CI 33	SC 4.8.1	P 73	L 12	# 19
LANDRY, MA	TTHEW	SILICON LABS		
Comment Ty	pe T	Comment Status D

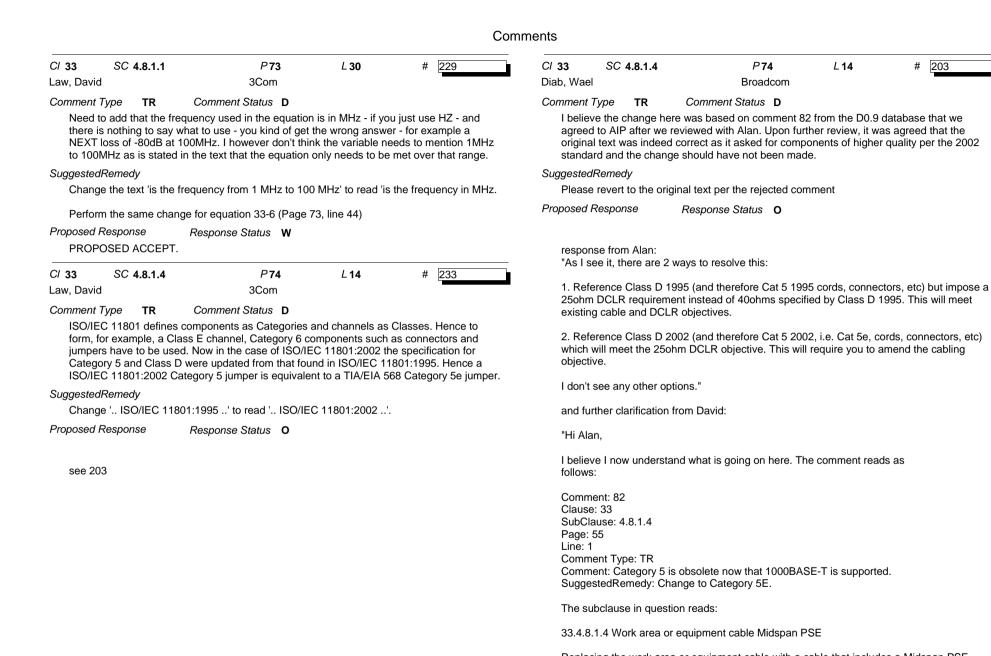
This line references "ISO 11801:2002." Is this correct? Or do we want to reference "ISO/IEC 11801:1995?"

Pick the right ISO/IEC 11801 reference and make it consistent throughout the document.
